Discontinued product  
INLINE GAS FILTER

Recommended substitute product  
INLINE GAS FILTER

TF/STF-4 SERIES

TF/STF-MF1 SERIES

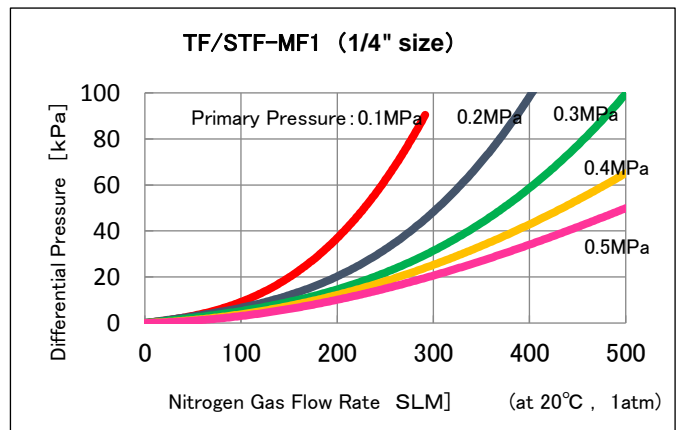
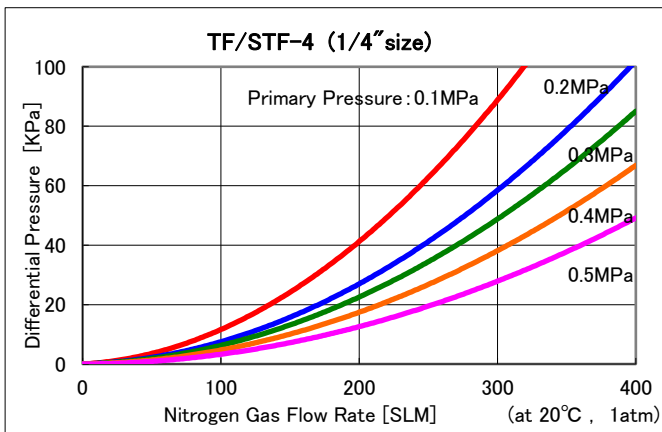
## End of production at the end of May

### Differences from production discontinued products

Model	Material				Specification	Size
	Housing	Element membrane	Element support	O-ring	Removal rating	Interplane dimension
TF/STF-4 SERIES	SUS316L	PTFE	ECTFE	PTFE	0.01 $\mu$ m (TF)	In the case of the same joint The same interplane dimension
TF/STF-MF1 SERIES			PFA	UNUSED	0.003 $\mu$ m (STF)

TF / STF - MF1 has lower pressure loss than TF / STF - 4.
